ADDENDUM NO.: FIVE DATE: 20 March 2014

PROJECT TITLE: Indoor Practice Facility Construction

University of South Carolina Columbia, South Carolina

PROJECT NO.: State #H27-6090-MJ WTS No. 12710

GRADING AND SWPP PLAN

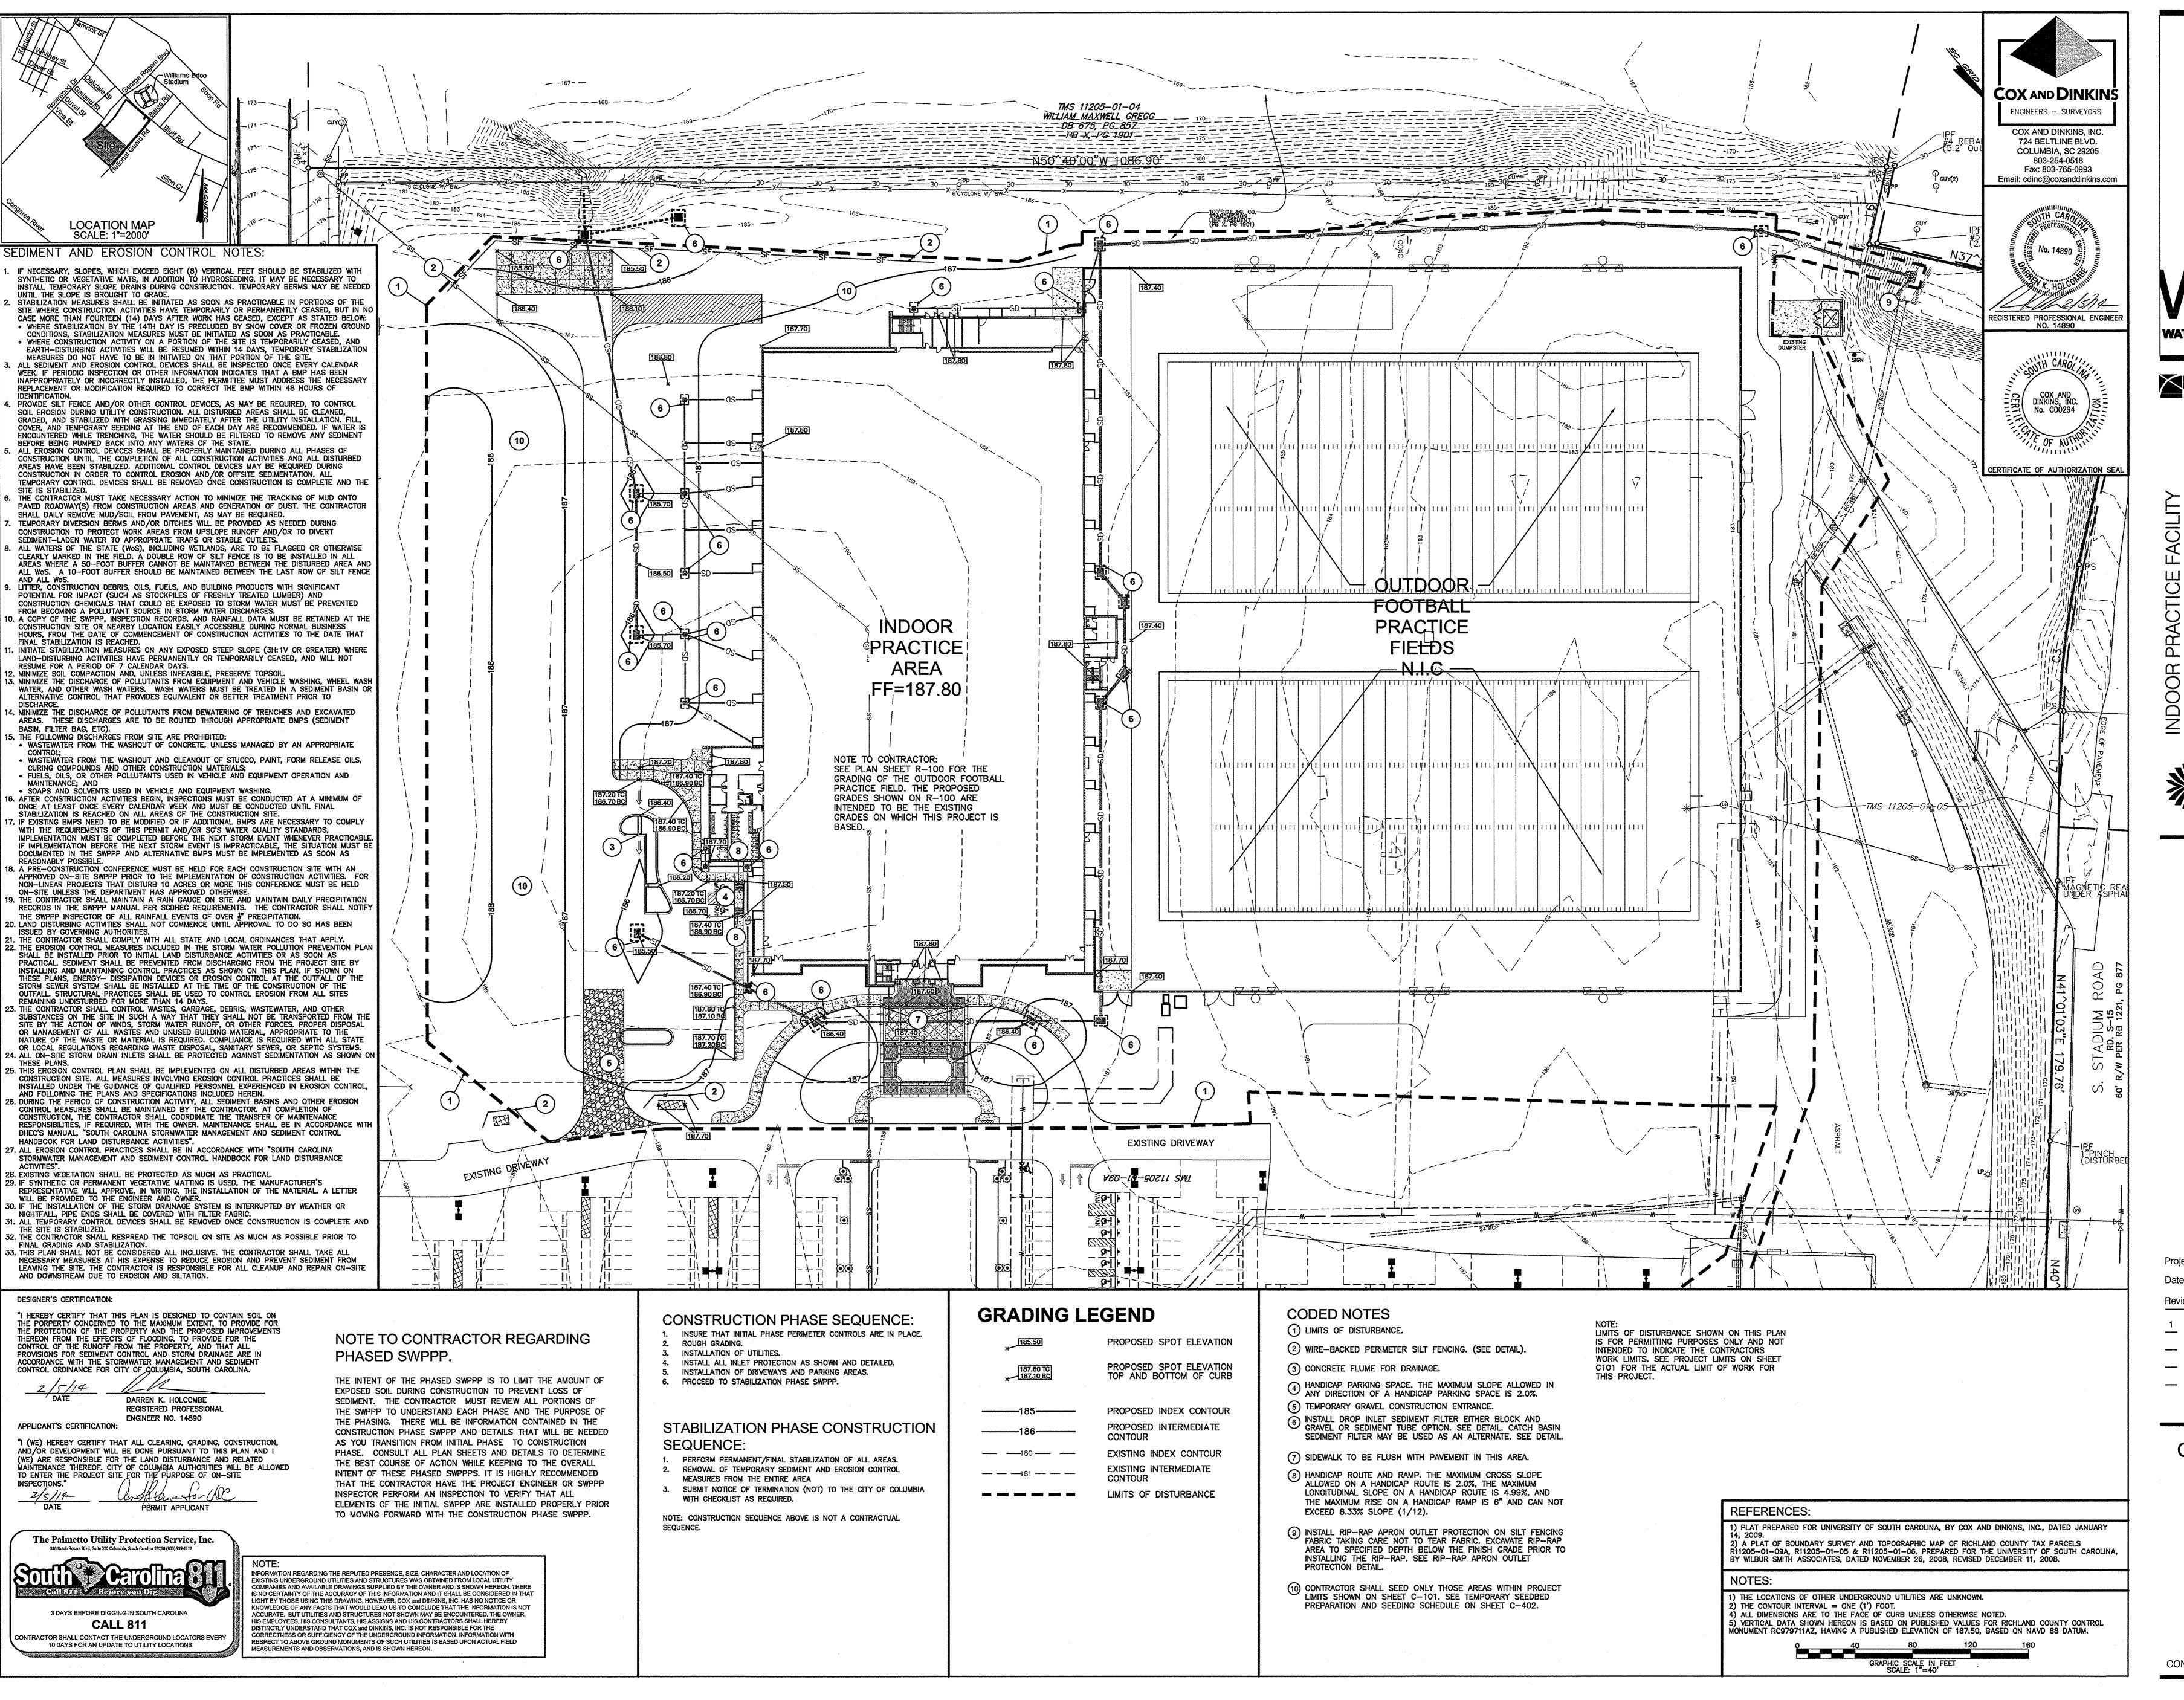
1. C-201 Grading and SWPP Plan - replace sheet C-201 with the attached, C-201.

1 3/20/14 REVISE S&EC NOTES
